SITE PLAN
7ELEVEN AT WALLBROOK (LOT 11)
Town of Rolesville Project No. SDP 23-04
US 401 Business / S. Main Street & Virginia Water Drive
Wake Forest Township, Town of Rolesville, Wake County, North Carolina

C2.0
Date: May 1, 2023

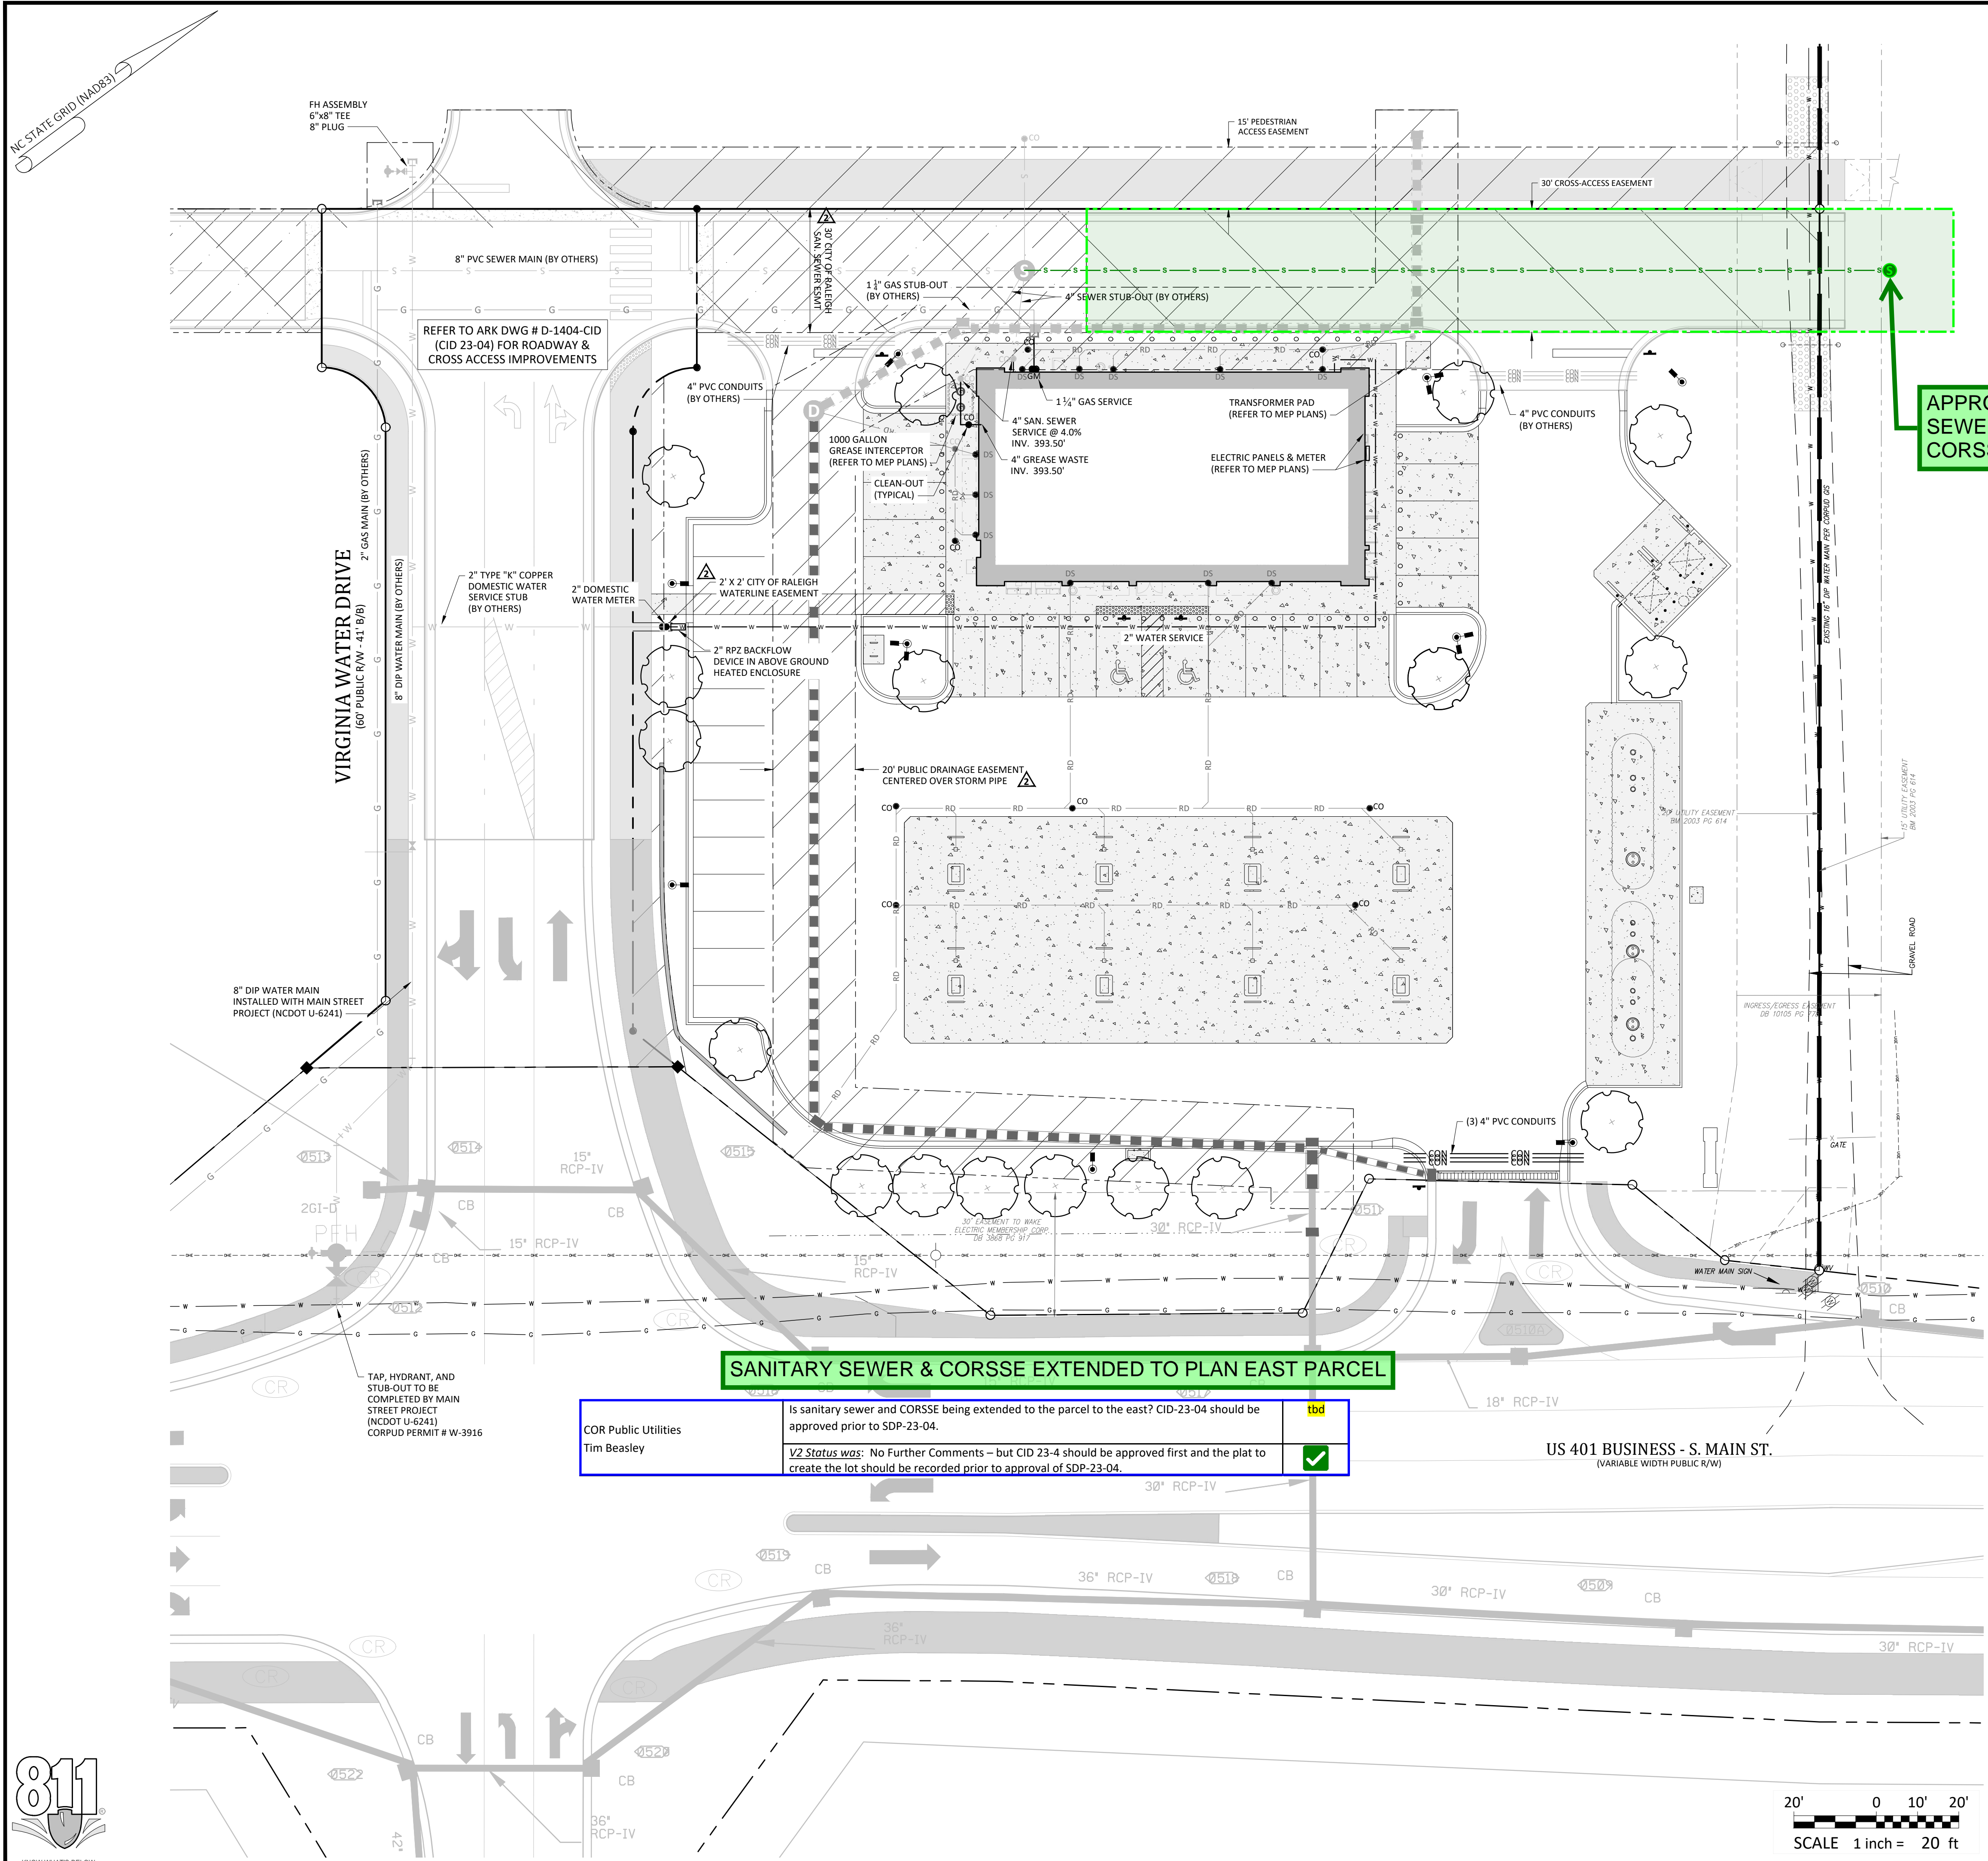
4. Subdivision of Lot 11 - This development is for Lot 11 per PR 21-04; currently, this lot does not exist/is not Recorded as such, but rather, per BM2023/pg1603-1604, and Town FSP-23-10, this development lies within a portion of "Tract B", which includes the future Right-of-way of the Virginia Water Drive extension north/west of Main Street. Lot 11 must be recorded - and thus, the Virginia Water Drive right-of-way dedicated via plat recordation - before final signature and approval of this SDP can occur.

5. Repeat/There was no Written Response to this - Regarding All Easements - If BM/Bk & Pg reference is not provided, all shown easements are thus PROPOSED - please explain WHEN these easements intend to be recorded. Clarify if Applicant seeks Final, signature approval of SDP-23-04 to allow ultimate site development to commence, without first Recording easements that are predating the development. See COR-PUD Comment; COR-PUD expects Lot 11 to be recorded, and presumed that all Proposed Easements are actually Recorded Easements, prior to signature/approval of Site Development Plan.

6. Repeat/There was no Written Response to this - (Partial Repeat) Sheet Index - There are two Sheets C1.3 (the 6th and 7th sheet in the set) - there is no Sheet C1.4, suggest changing the 2nd one to this and add to Sheet index.

4. THIS WAS DONE INTENTIONALLY, THROUGH COORDINATION WITH TOWN STAFF, TO PROVIDE A MECHANISM FOR THE TOWN TO WITHOLD CERTIFICATE OF OCCUPANCY UNTIL THE STREET WAS SUBSTANTIALLY COMPLETE, OR BONDED, AND THE RIGHT OF WAY DEDICATED. THIS IS A CARBON COPY OF HOW PUBLIX (SDP 23-05) IS SETUP AND WAS APPROVED.

5. PROPOSED UTILITY & DRAINAGE EASEMENTS WILL BE RECORDED AT OR NEAR CONCLUSION OF INSTALLATION, PRIOR TO ACCEPTANCE BY UTILITY OWNER; WHICH IS HOW IT IS CURRENTLY BEING HANDLED ON PUBLIX (SDP 23-05). ACCESS & GREENWAY EASEMENTS TO BE RECORDED CONCURRENTLY WITH RIGHT-OF-WAY DEDICATION.

6. SHEET INDEX REVISED

C3.0

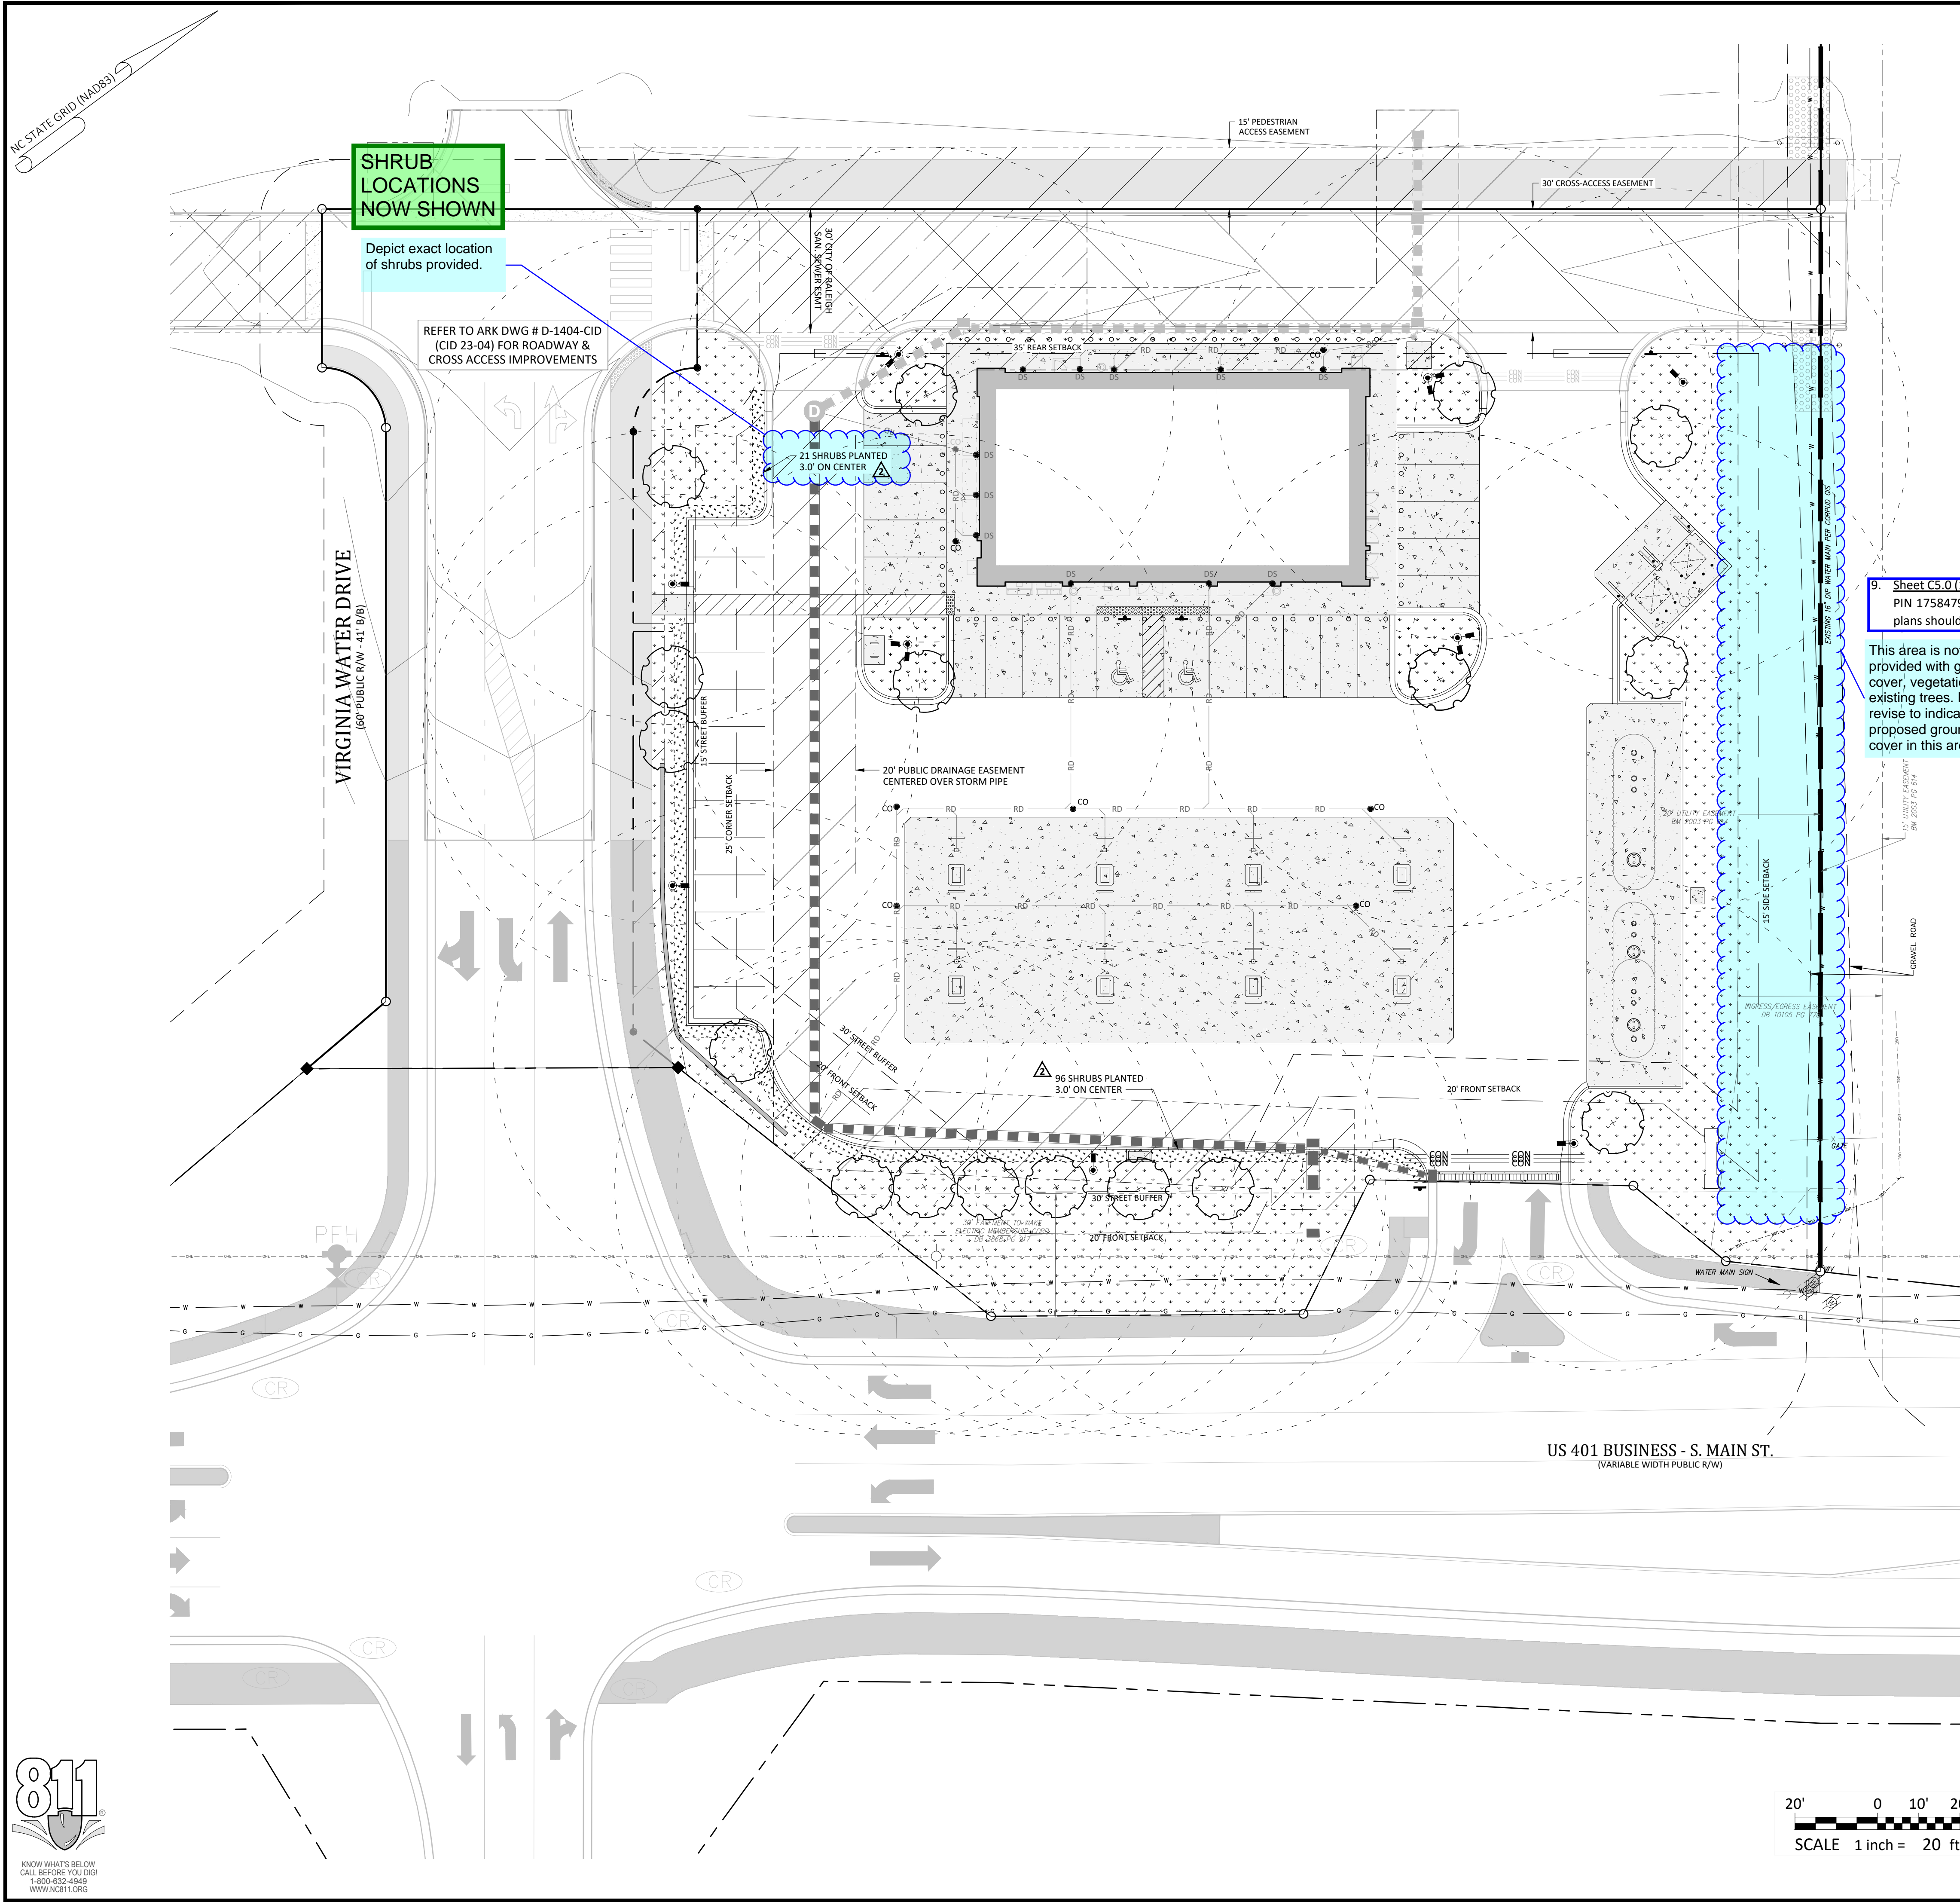
COR Public Utilities Tim Beasley	Is sanitary sewer and CORSE being extended to the parcel to the east? CID-23-04 should be approved prior to SDP-23-04.	tbd
	V2 Status was: No Further Comments – but CID 23-4 should be approved first and the plat to create the lot should be recorded prior to approval of SDP-23-04.	✓

C5.0
 Date: May 1, 2023

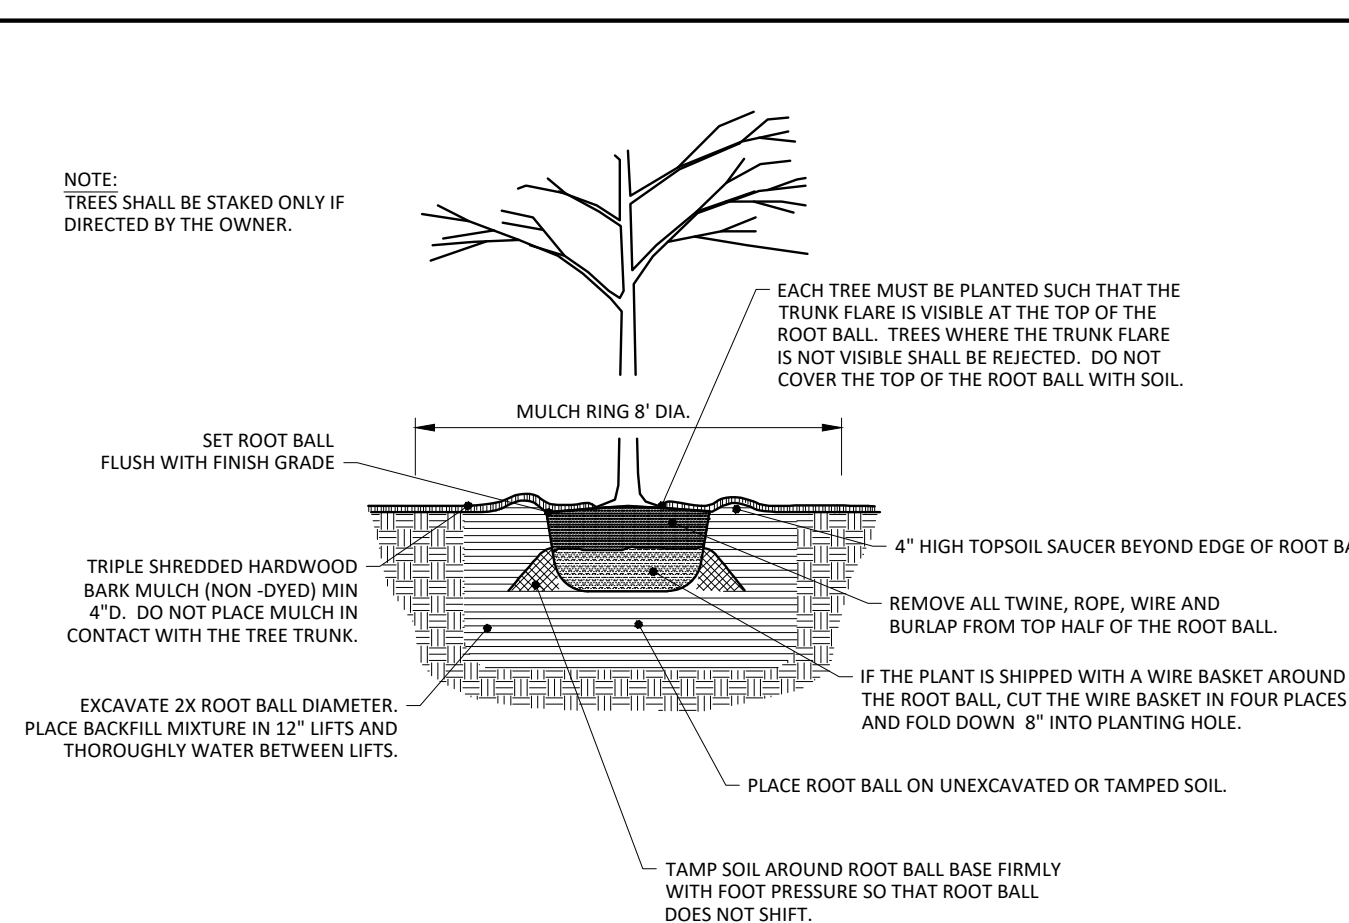
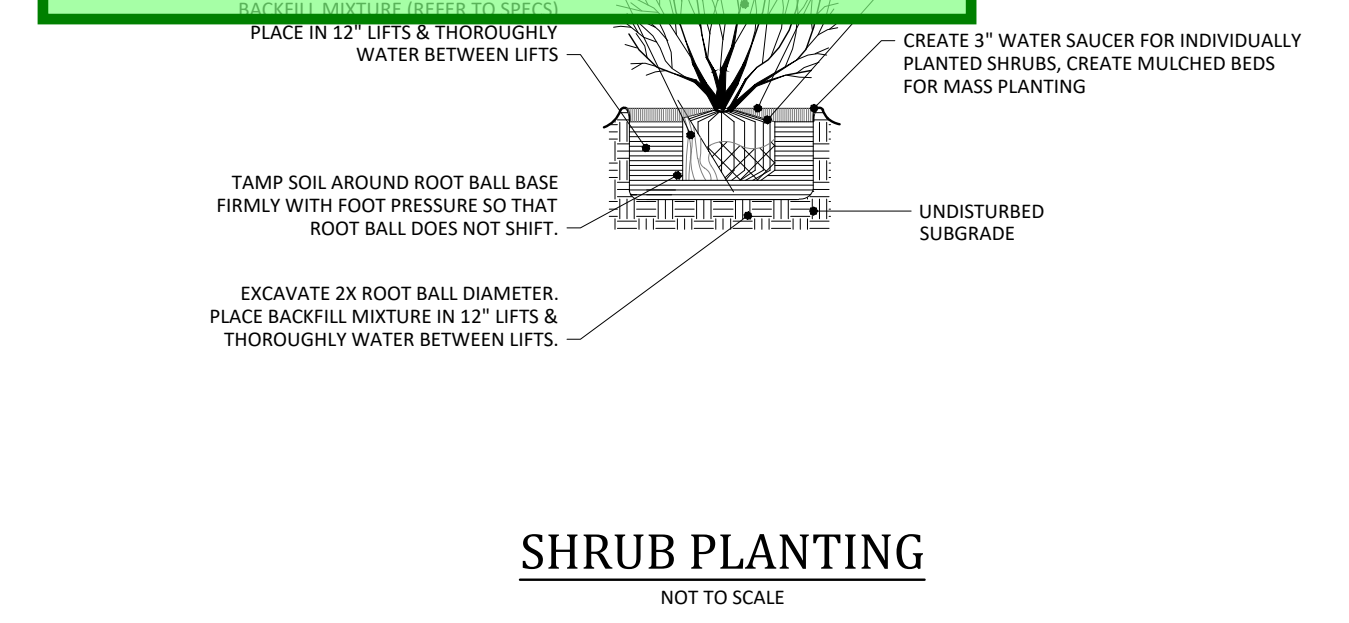
9. Sheet C5.0 (11 of 25) - The area of the Ingress/Egress utility easement (City of Raleigh) along the property line with PIN 1758479244 is not shown to be planted with sod, nor is it shown to preserve any existing landscaping. The plans should be revised to clearly indicate the proposed ground cover and/or landscaping to be provided here.

This area is not provided with ground cover, vegetation, or existing trees. Please revise to indicate the proposed ground cover in this area.

THIS AREA IS OUTSIDE THE LIMITS OF DISTURBANCE AND WILL REMAIN IN ITS EXISTING GROUND COVER CONDITION. SOD IS PROPOSED IN AREAS THAT ARE TO BE DISTURBED. NOTE ADDED TO SHEET C1.0.
